***Enbridge Pipelines Inc – Hilton Pumping Station
Modification of 115 kV Substation (CAA ID No: 2001-EX001)***

Notification of Approval of Connection Proposal

ASSESSMENT SUMMARY

ENBRIDGE PIPELINES INC. MODIFICATION OF 115 KV SUBSTATION AT HILTON PUMPING STATION

FIGURE 1

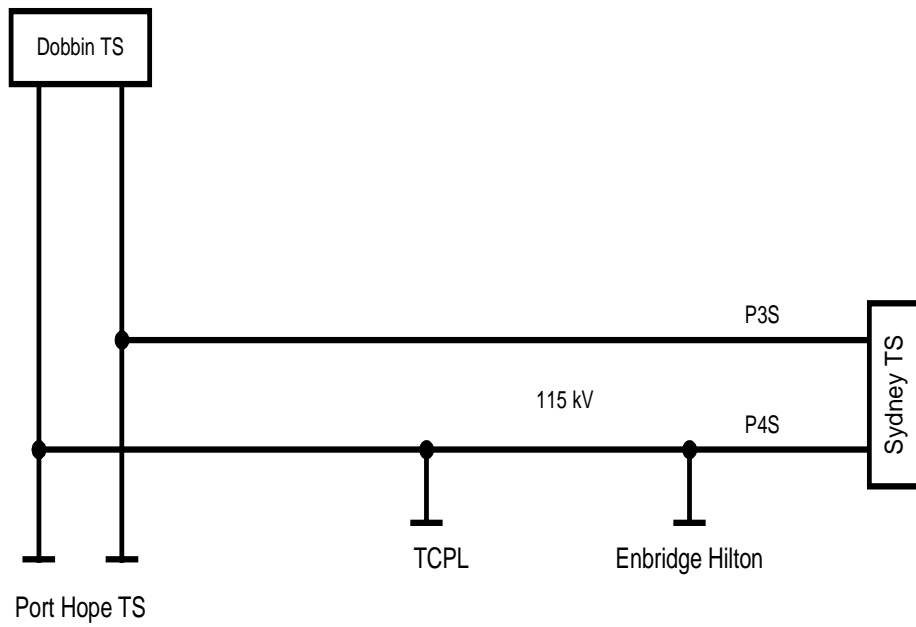
Enbridge's Hilton Pumping Station, near Trenton in Eastern Ontario is supplied at 115 kV via Hydro One's 115 kV circuit P4S as shown in Figure 1. Their 115 kV substation consists of a 7.5 MVA transformer and associated switchgear, protections and controls. The company is proposing to upgrade their substation protections which will entail the following work:
